UNITED STATES PATENT AND TRADEMARK OFFICE

APPLICATION NO.	FILING DATE	FIRST NAMED INVENTOR	ATTORNEY DOCKET NO.	CONFIRMATION NO.
10/554,196	10/24/2005	Hans-Peter Andra	000008-005	2655

Office Action Summary	Application No. 10/554,196	Applicant(s) ANDRA ET AL.	
	Examiner JAMES J. BUCKLE JR	Art Unit 3633

DETAILED ACTION

Fig. 2

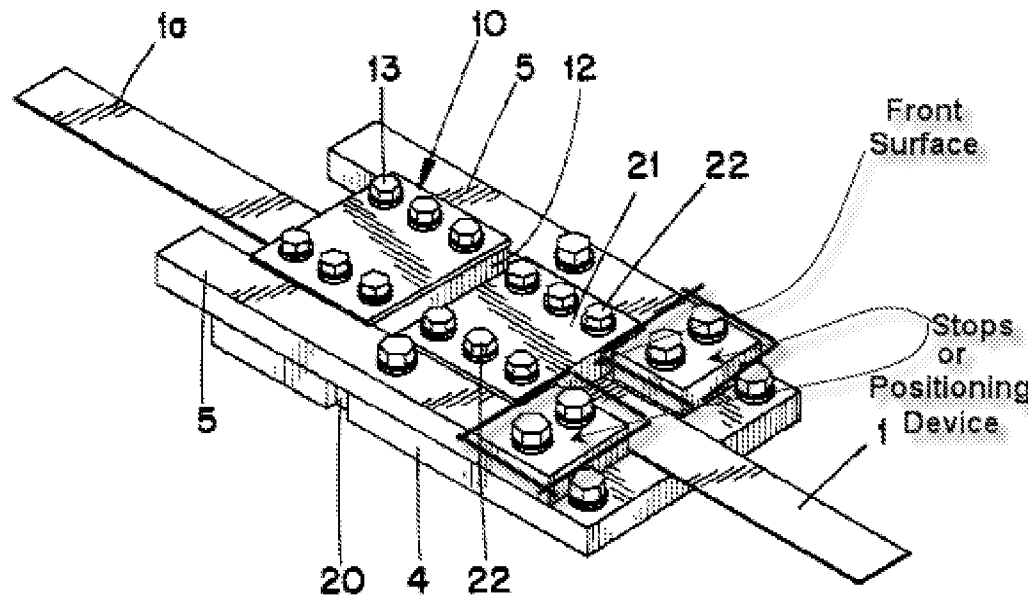
4. Regarding claim 2, Andrä et al. discloses the clamping plate (21) on either side of the traction element (1) comprising in each case a downwardly protruding securing tappet (22) which engages, in each case a securing recess of the base plate (Fig. 2). Examiner's considers applicant failure to address the argument of the bolts (13, 22) being equivalent to the tappet to be admission as prior art.

6. Regarding claim 4, Andrä et al. discloses (Fig. 2) the clamping plate with its front surface facing in the direction of the traction force that is supported against two "stops" (Stops, Fig. 2) that are connected with the base plate (4,5,11).

7. Regarding claims 6,12-13 and 16, Andră et al. discloses the clamping plate that is fixed in position by a positioning device (Positioning Device) which engages the clamping plate (21) in the direction of the traction force in “positive fitting” support against the base plate (4,5,11).
